Azoteq Product Change Notice:

IQS360

Issued Date: 15 December 2014

PCN Number: ACN_360_01

Figure 2.1 Changes in Package Dimensions. Drawing for illustration only, not to scale.

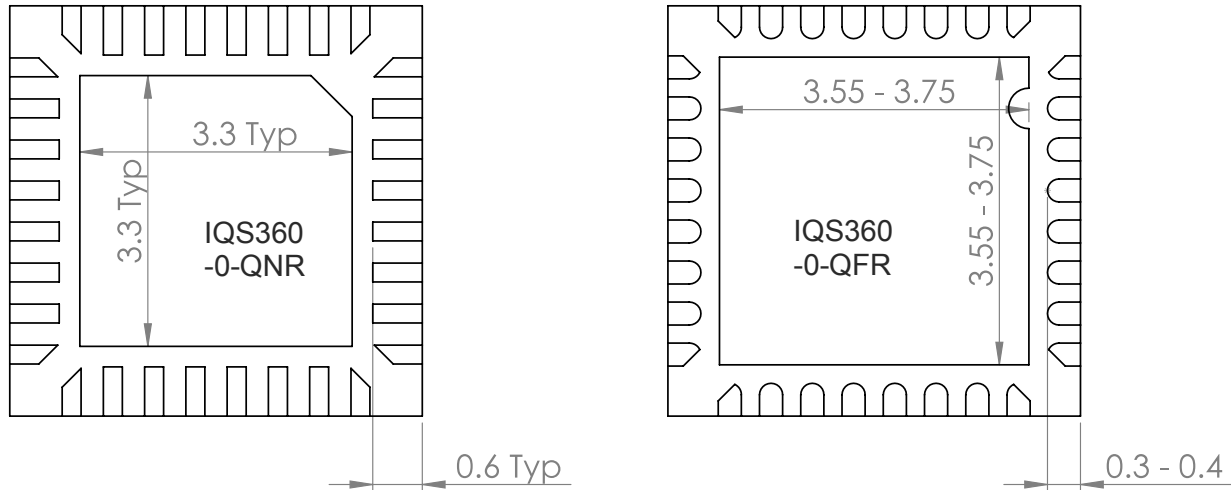
The overall physical size of the part ($l \times w \times h$) and pitch of the pins did not change.

The mechanical dimensions of the saddle and length of the pins have changed from the old part (IQS360-0-QNR) to the new part (IQS360-0-QFR). The new dimensions are given below:

The bonding diagram, and therefore the pin out, has not been affected.

Since the package has changed, an update to the PCB footprint is required.

Change the PCB footprint during the next board design cycle to facilitate placing the new part.
